Contract #: 04-0120F4
 Cty: SF/ALA Rte: 80 PM: 13.2/13.9
 File #: 69.25B

QUALITY ASSURANCE -- NON-CONFORMANCE REPORT

Report No: NCR-000797

Reference Description: Unapproved Wrapped Welds - Lift 13 Floorbeams

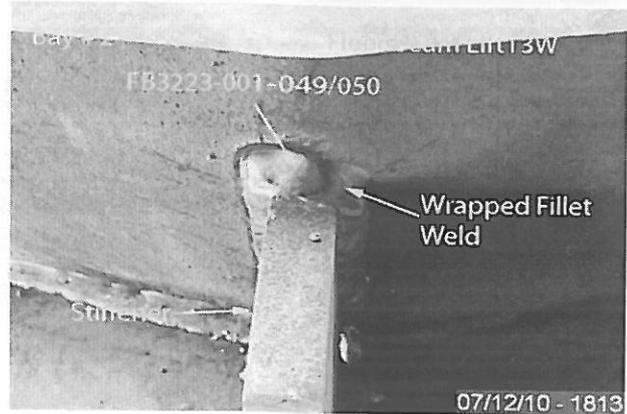
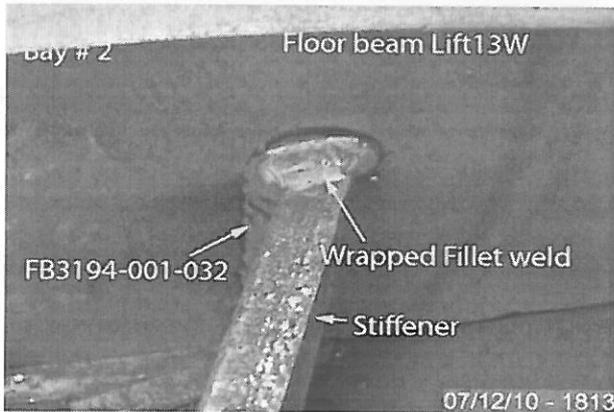
-ZPMC personnel welded without according to the approved shop drawings by wrapping the welds around at the ends of the stiffeners.

-The affected Floor beam welds are identified as FB3194-001-032,035,036,025,026 and FB3223-001-049,050.

-This Floor beam is located in Sub assembly Bay#2.

For further information, please see the attached pictures below.

Remove said unapproved welds and perform NDT required to verify base metal was not affected.

Contractor removed welds in said locations and submitted NDT reports verifying adjacent base metal was not damaged.
